SUMMARY OF PROPOSED AMENDMENTS SK01

STAGE 1 TYPICAL LEVEL  
8 UNITS (MAX) PER CORE.

STAGE 2 TYPICAL LEVEL  
8 UNITS (MAX) PER CORE SK 03

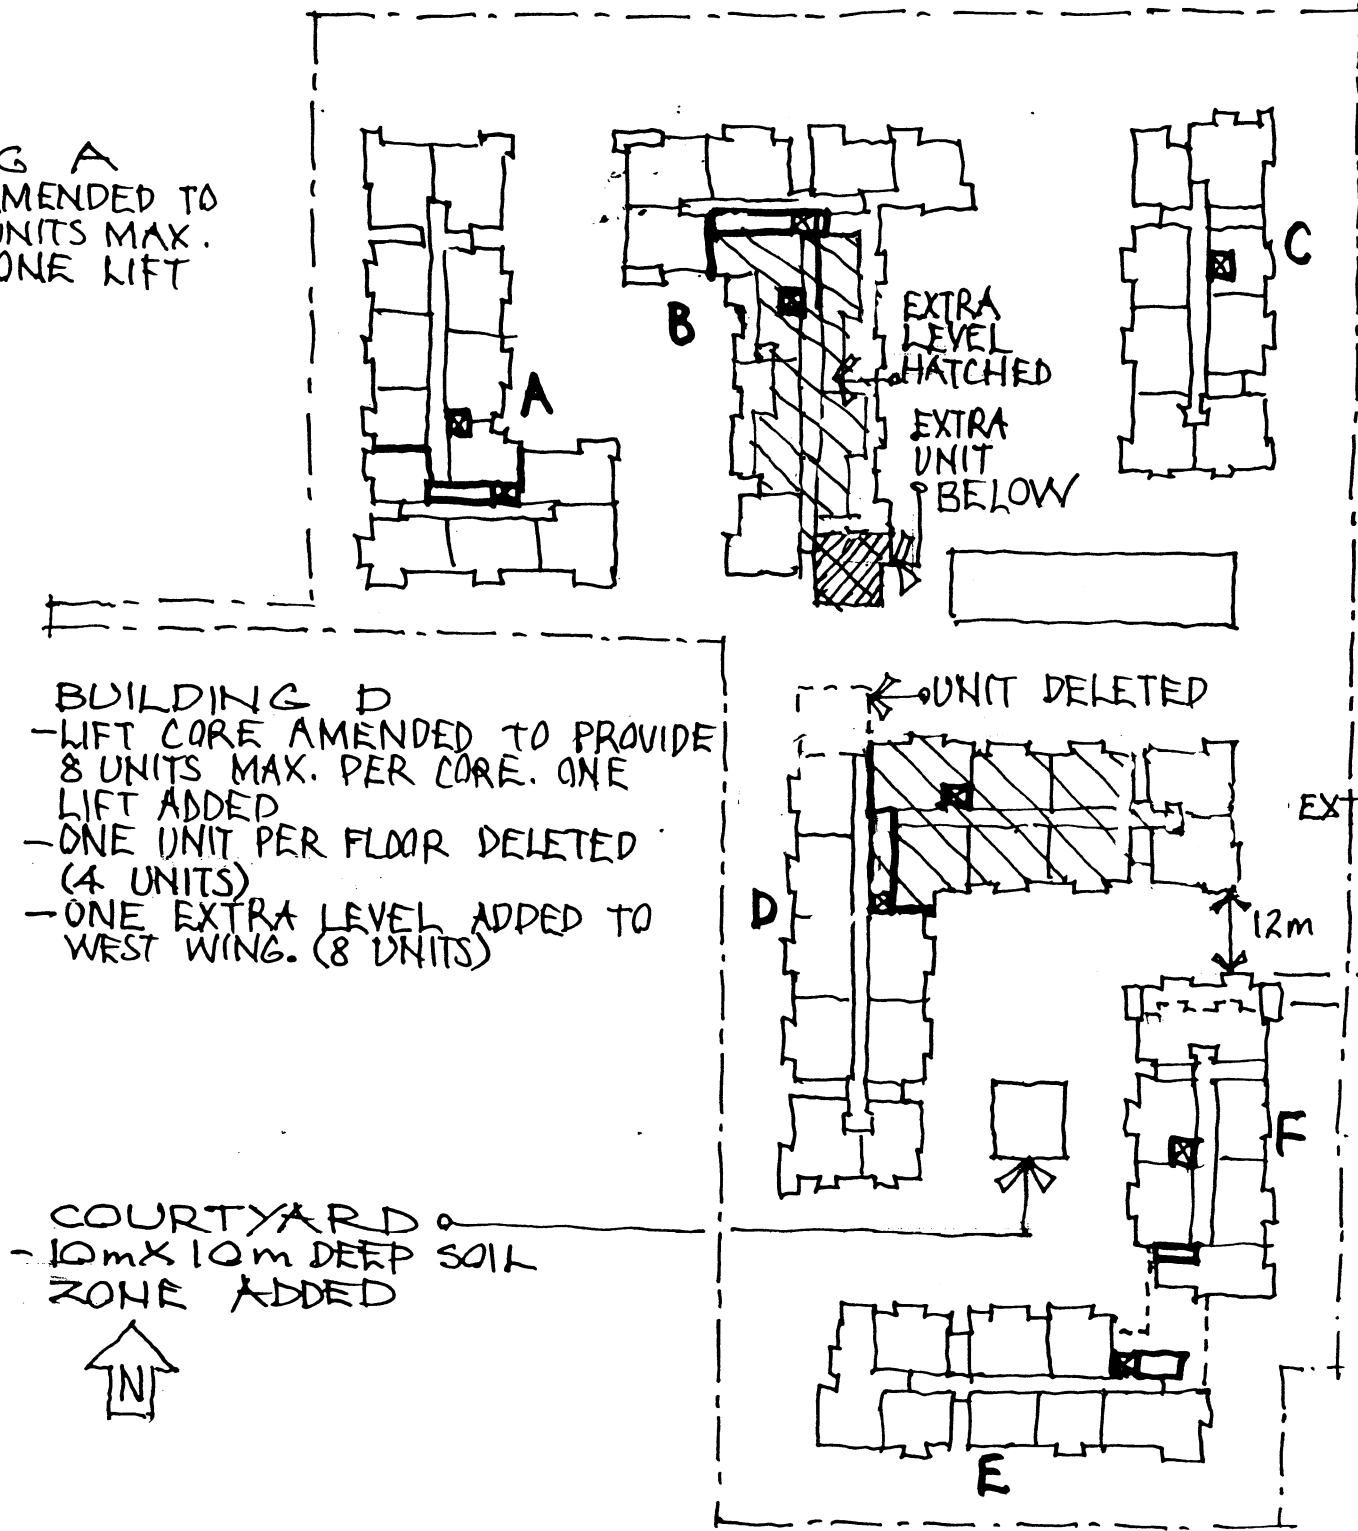
- BUILDING B**
- LIFT CORE AMENDED TO PROVIDE 8 UNITS MAX. PER CORE. ONE LIFT ADDED.
  - ONE ADDITIONAL UNIT PER FLOOR ADDED (4 UNITS)
  - ONE ADDITIONAL LEVEL ADDED TO SOUTH WING. (8 UNITS)

- BUILDING A**
- LIFT CORE AMENDED TO PROVIDE 8 UNITS MAX. PER LIFT. ONE LIFT ADDED

- BUILDING C**
- ONE FULL LEVEL DELETED (8 UNITS)

- BUILDING D**
- LIFT CORE AMENDED TO PROVIDE 8 UNITS MAX. PER CORE. ONE LIFT ADDED
  - ONE UNIT PER FLOOR DELETED (4 UNITS)
  - ONE EXTRA LEVEL ADDED TO WEST WING. (8 UNITS)

- COURTYARD**
- 10m x 10m DEEP SOIL ZONE ADDED

- BUILDING E**
- BUILDING SEPARATED INTO TWO BUILDINGS.
  - EXTRA LIFT & STAIRS ADDED.
  - NORTHERN WING, NOW CALLED 'BUILDING F', MOVED 3 METRES NORTH
  - ONE FLOOR DELETED FROM BUILDING F. (7 UNITS)

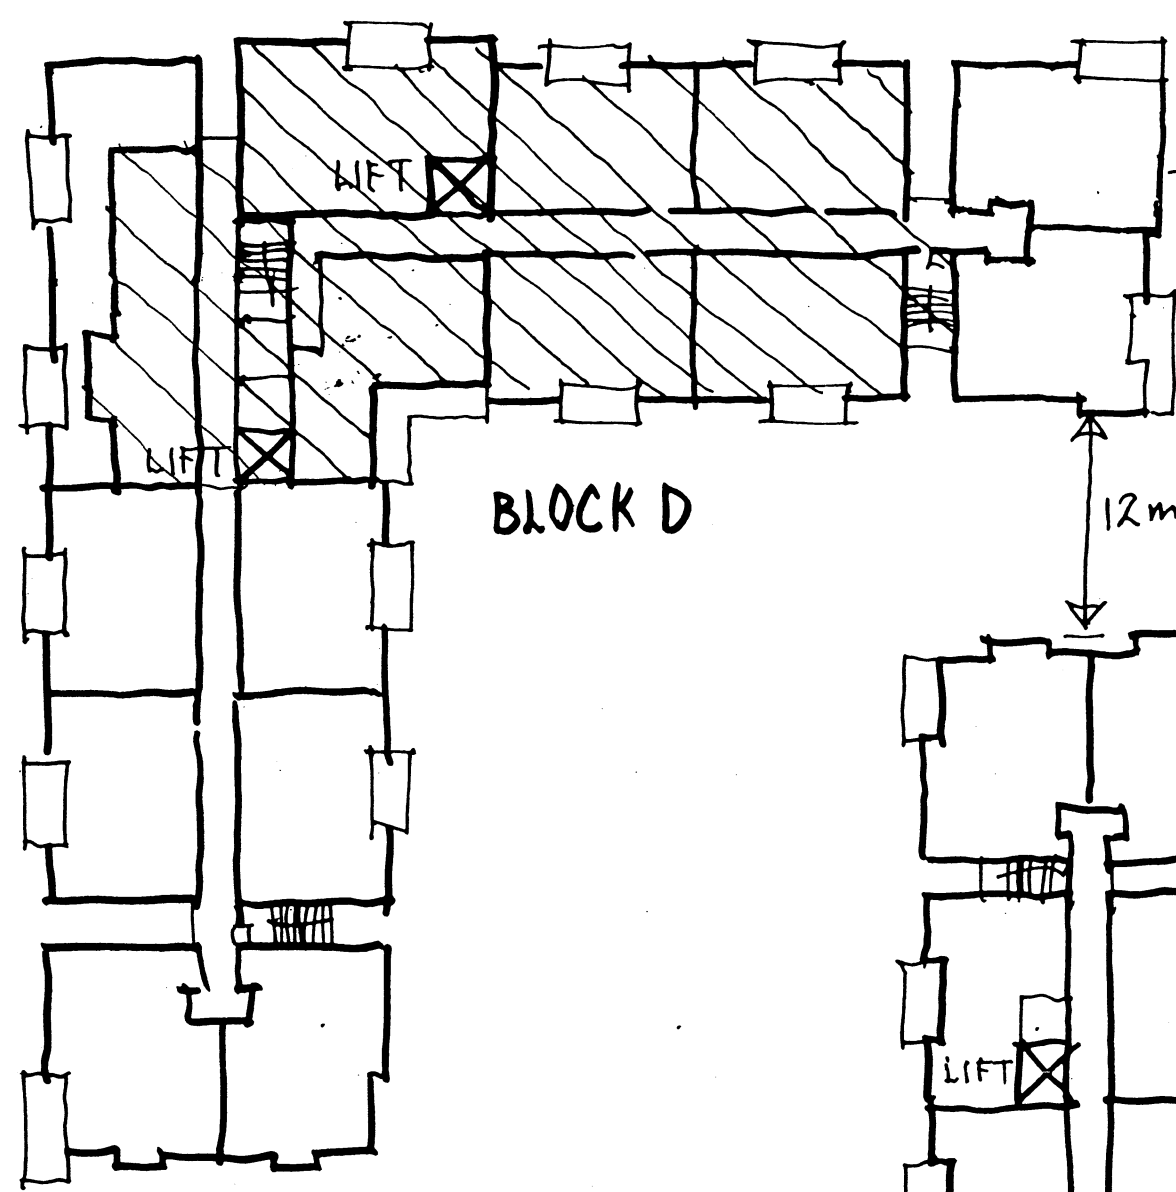
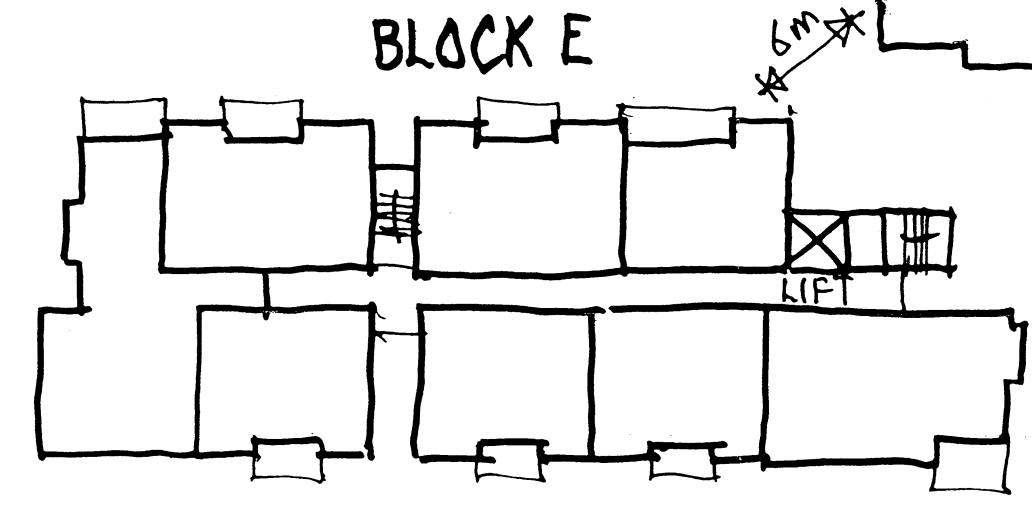
EXTENT OF EXTRA LEVEL SHOWN HATCHED

ONE LEVEL DELETED FROM BUILDING F
